APPLICATION NO.	FILING DATE	FIRST NAMED INVENTOR	ATTORNEY DOCKET NO.	CONFIRMATION NO.
10/691,213	10/22/2003	Alfons Resing	09197-US	8365

Office Action Summary

DETAILED ACTION

6. Claims 1, 7, 11-13, 16-17 are rejected under 35 U.S.C. 102(e) as being anticipated by Wiegert (6412259).

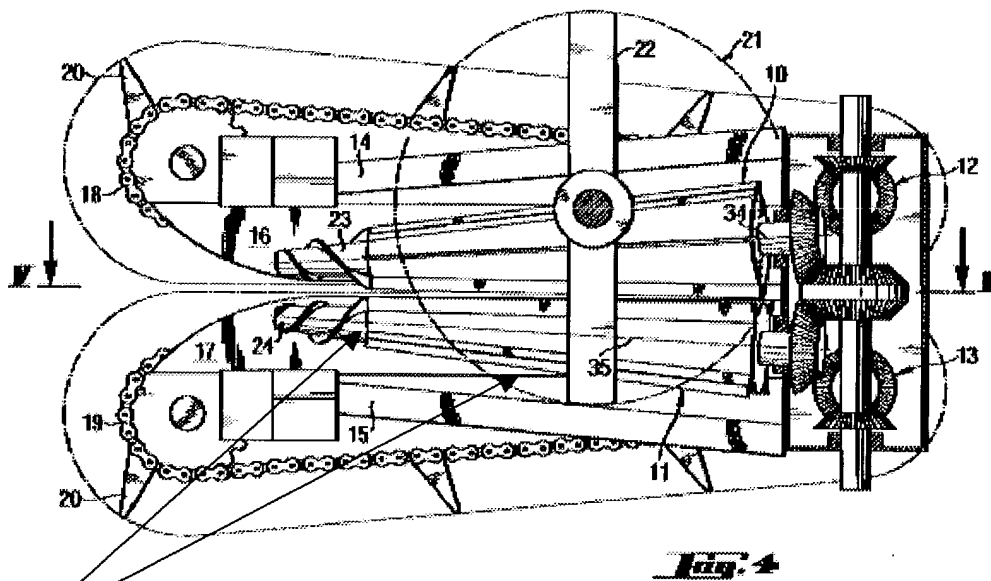
Roll body changes continuously & the drivers in complementary fashion (cl. 1, 7, 11, 12, 13, 16-17)

7. Claims 1, 8-9, 11-13, 16-17 are rejected under 35 U.S.C. 102(b) as being anticipated by Schreiner (3462928).

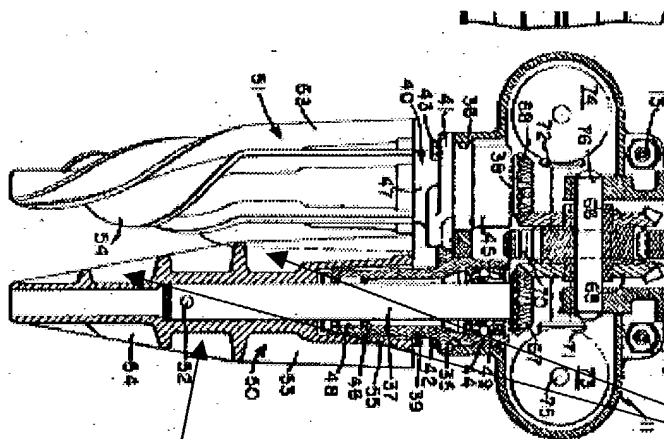
The body changes in step like fashion (cl. 8)

The drivers change in step like fashion and/or continuous fashion in complementary fashion (cl. 1, 9, 11, 12, 13, 16-17)
